Enclosure 3 to AEP:NRC:4565

CRITICALITY ANALYSES FOR THE SPENT AND NEW FUEL STORAGE RACKS

**D.C. Cook Units 1 and 2 Criticality
Evaluation Using Framatome Fuel**

77-5040212-00

Figure 5.6-4: New Fuel Storage Rack Integral Fuel Burnable Absorber (IFBA) Requirements

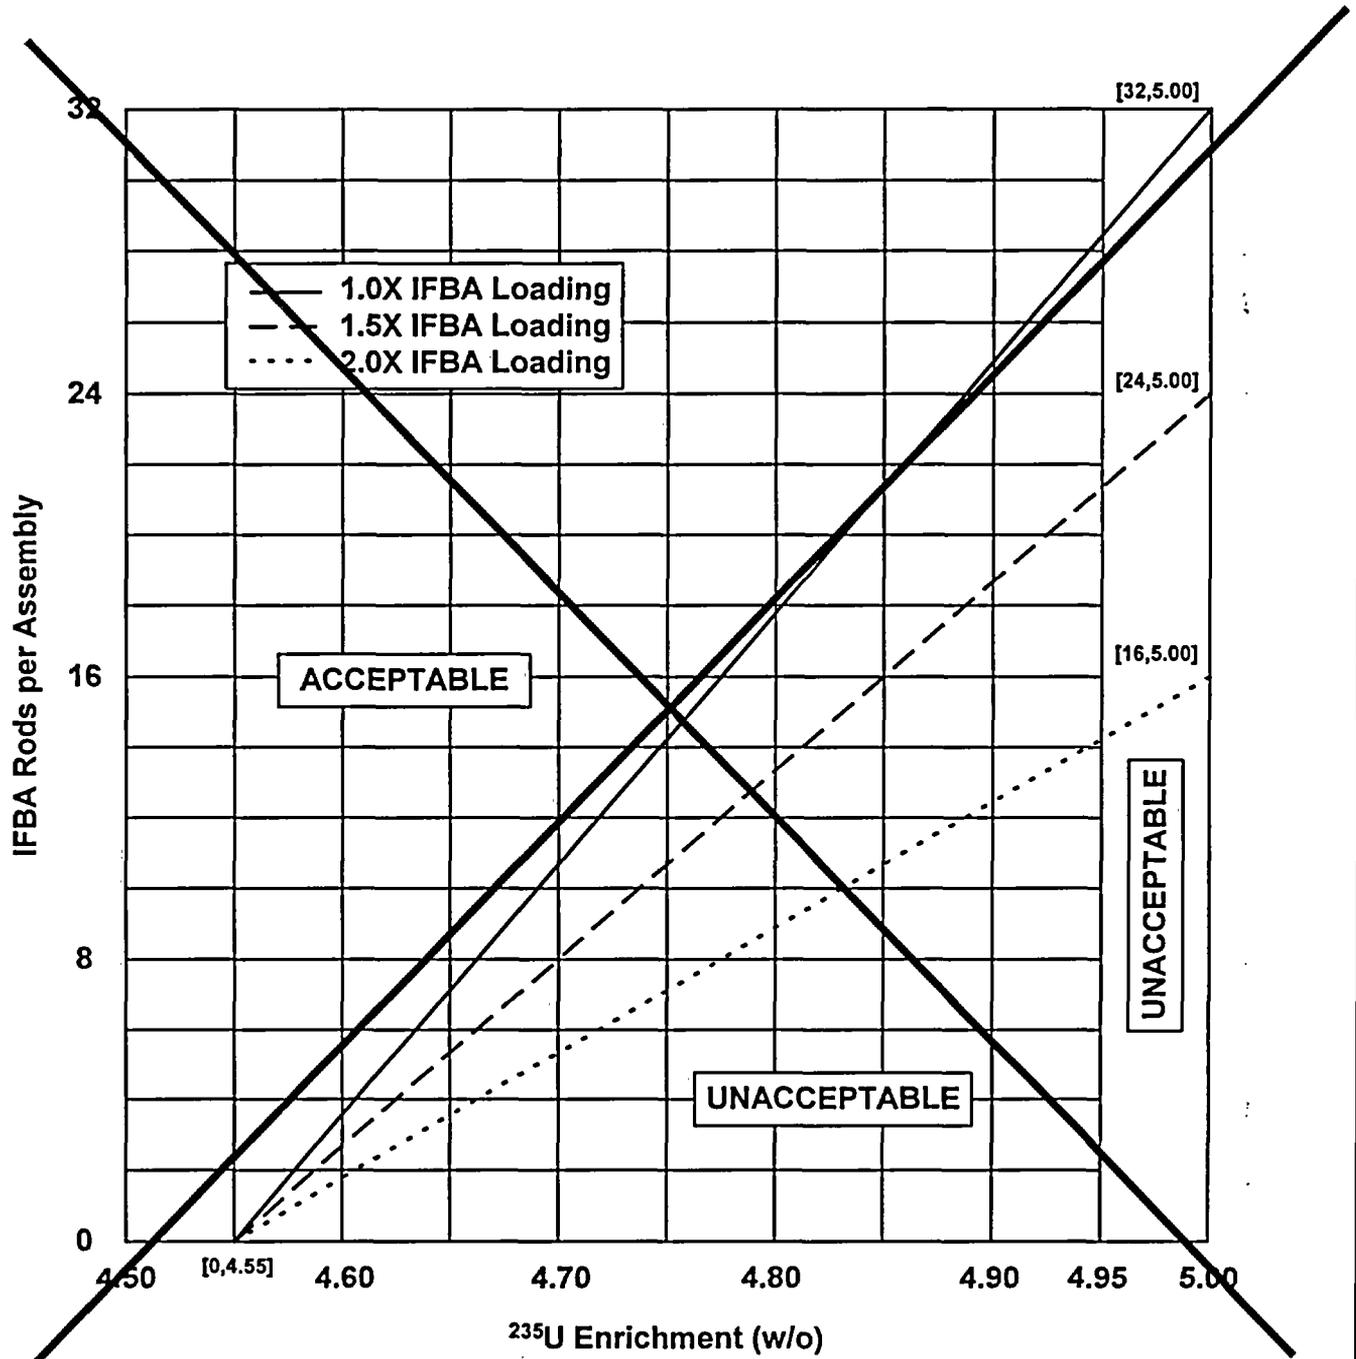
- a. ~~Westinghouse fuel assemblies having either a maximum enrichment of 4.55 weight percent U-235, or an enrichment between greater than 4.55 and less than or equal to 4.95 weight percent U-235 with greater than or equal to the minimum number of integral fuel burnable absorber pins as shown on Figure 5.6-4 (interpolation of the Boron-10 loading between 1.0X and 1.5X and between 1.5X and 2.0X is acceptable)~~ a minimum of 4 symmetrically loaded Gadolinia fuel rods at a minimum of 2.0 weight percent Gadolinia;

Figure 5.6-4 intentionally deleted.

Figure 5.6 4: New Fuel Storage Rack Integral Fuel Burnable Absorber (IFBA) Requirements-

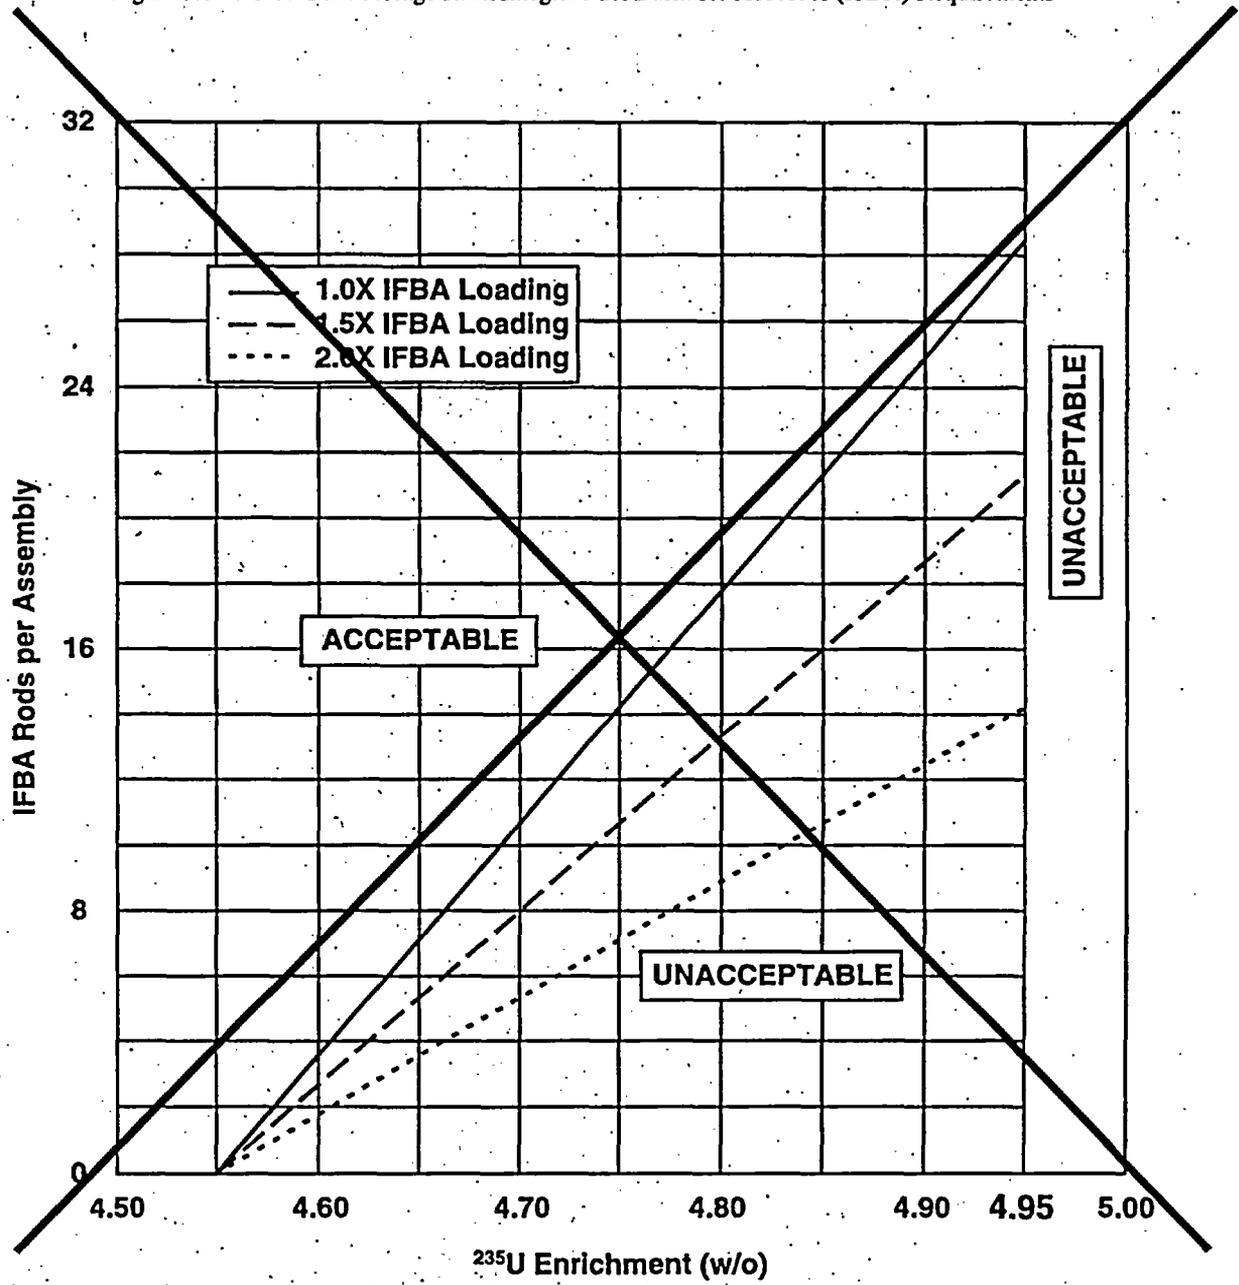
- a. Fuel assemblies having either a maximum enrichment of 4.55 weight ~~percent~~ U-235, or an enrichment between ~~greater than~~ 4.55 and ~~less than or equal to~~ 4.95 weight ~~percent~~ U-235 with the ~~minimum number of integral fuel burnable absorber pins as shown on Figure 5.6.4 (interpolation of the Boron-10 loading between 1.0X and 1.5X and between 1.5X and 2.0X is acceptable)~~ a minimum of 4 symmetrically loaded Gadolinia fuel rods at a minimum of 2.0 weight percent Gadolinia;
- b. $k_{eff} \leq 0.95$ if fully flooded with unborated water, which includes an allowance for uncertainties as described in Section 9.7 of the UFSAR;
- c. $k_{eff} \leq 0.98$ if moderated by aqueous foam, which includes an allowance for uncertainties as described in Section 9.7 of the UFSAR; and
- d. A nominal 21 inch center to center distance between fuel assemblies placed in the storage racks.

Figure 5.6-4 intentionally deleted.
